SUBJECT: COOPER NUCLEAR STATION - AMENDMENT NO. 121 TO FACILITY  
OPERATING LICENSE NO. DPR-46 (TAC NO. 67164)

AMENDMENT TO FACILITY OPERATING LICENSE

Amendment No. 121  
License No. DPR-46

SAFETY EVALUATION BY THE OFFICE OF NUCLEAR REACTOR REGULATION  
RELATED TO AMENDMENT NO. 121 TO FACILITY OPERATING LICENSE NO. DPR-46  
NEBRASKA PUBLIC POWER DISTRICT  
COOPER NUCLEAR STATION  
DOCKET NO. 50-298

FIGURE 2.1.1

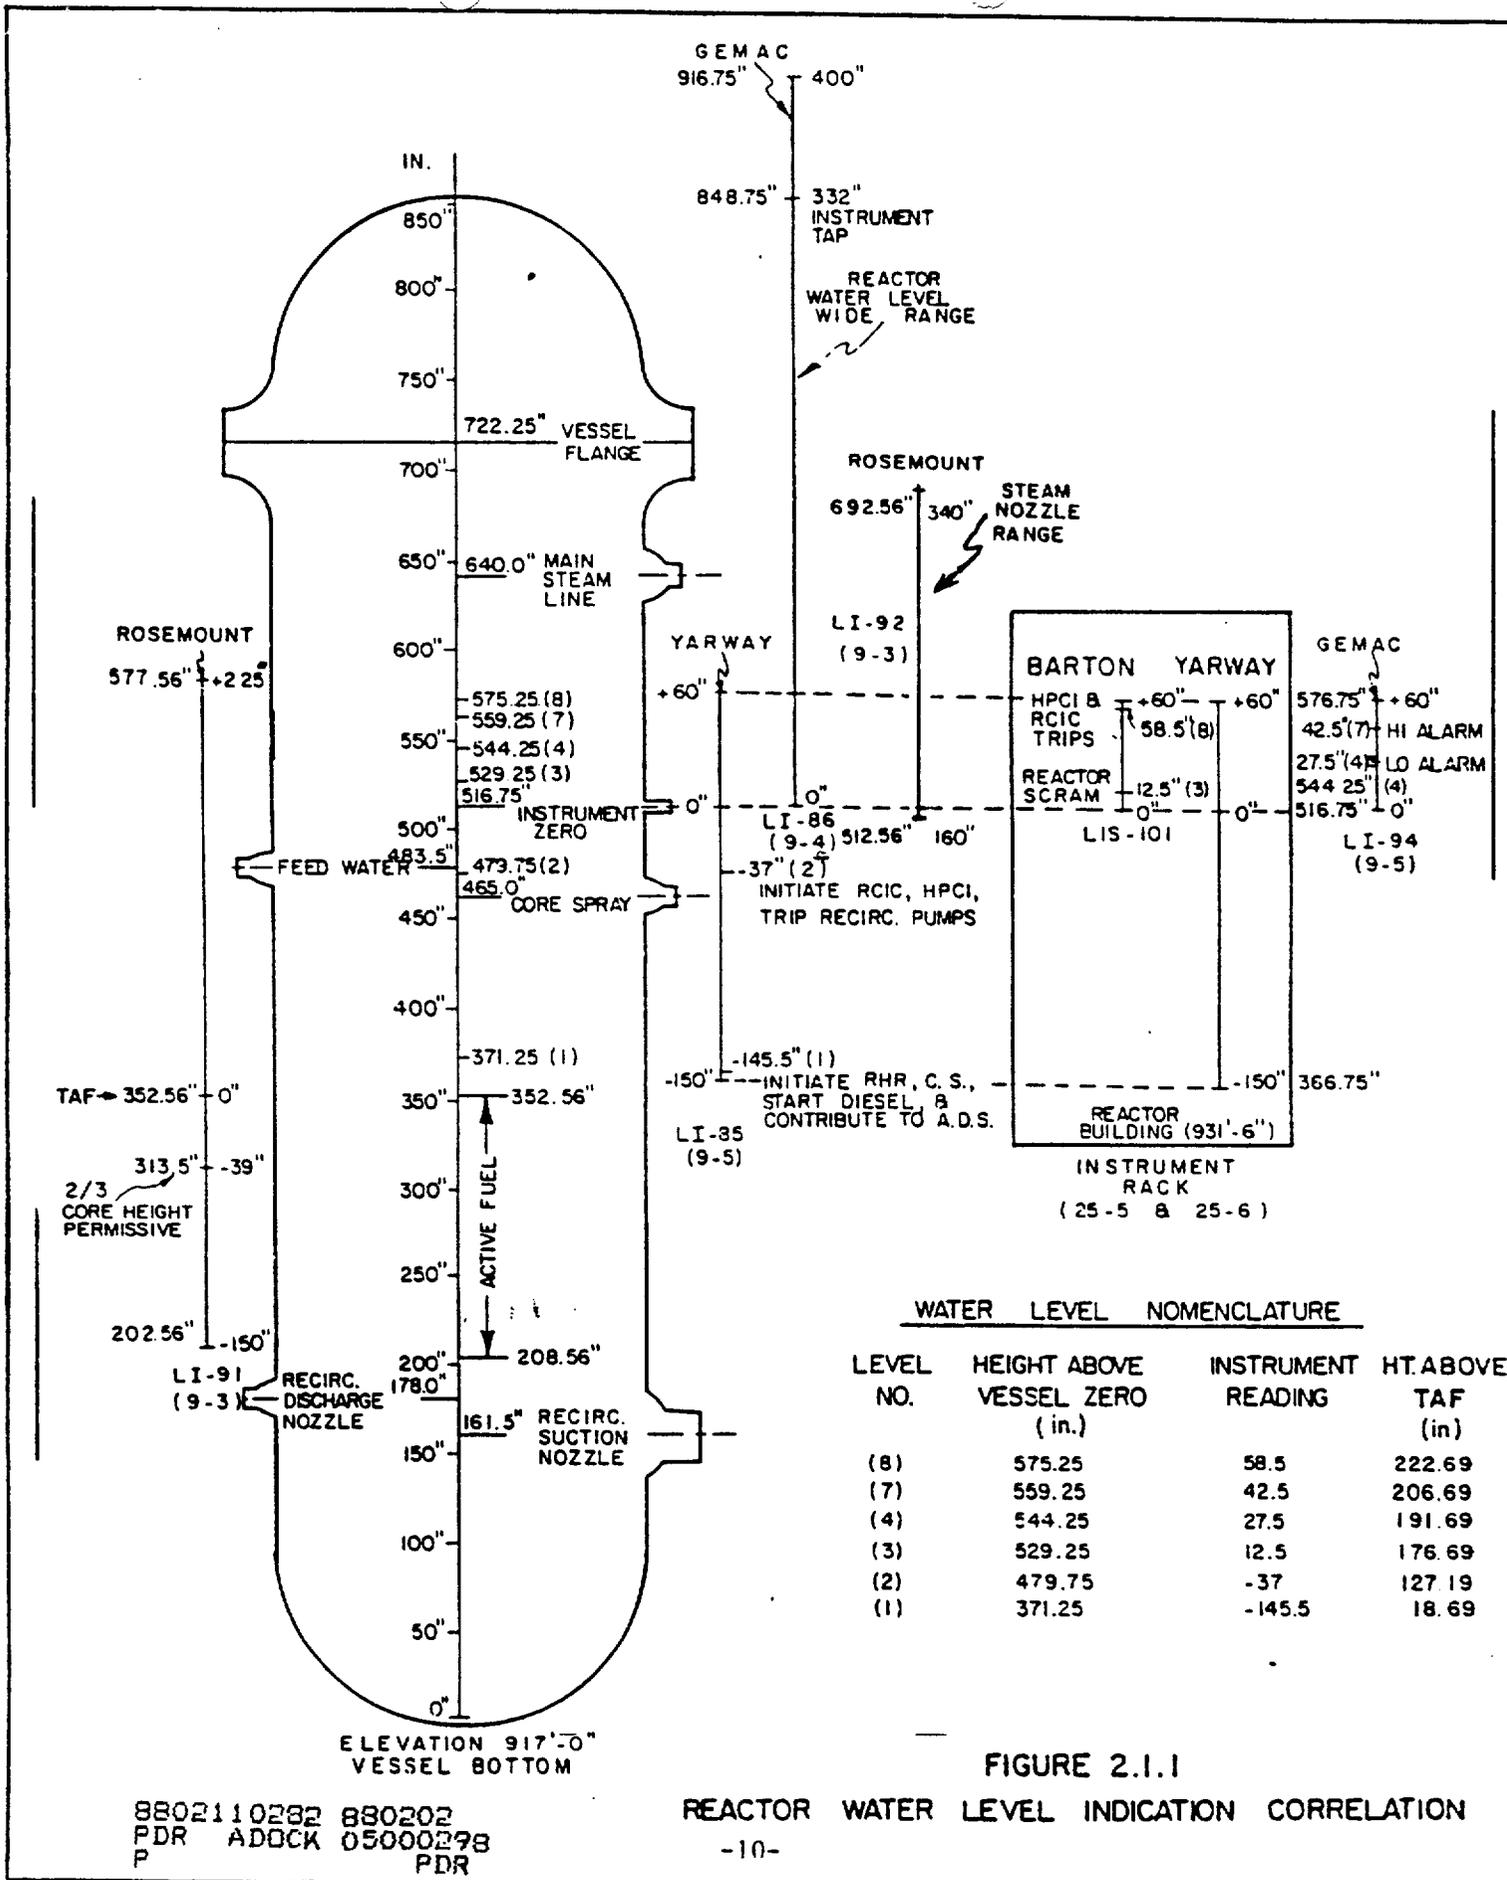
Reactor Water Level Indication Correlation Drawing: Figure 2.1.1 would be revised to reflect modifications to be made to extend the range of water level instruments in accordance with the licensee's Regulatory Guide 1.97 accident monitoring instrumentation commitments to provide improved capability to monitor reactor vessel water level. The modifications extend the range of water level monitoring down to 6 inches below the bottom of active fuel and up to the top of the steam separator. Based on conformance to previously approved Regulatory Guide 1.97 plans (Ref: Letter from W. Long to J. Pilant dated October 27, 1986) this change is acceptable. It is noted that this change does not add, delete or modify any limiting conditions for operation or surveillance requirements but serves only to update descriptive information contained in the Technical Specifications.
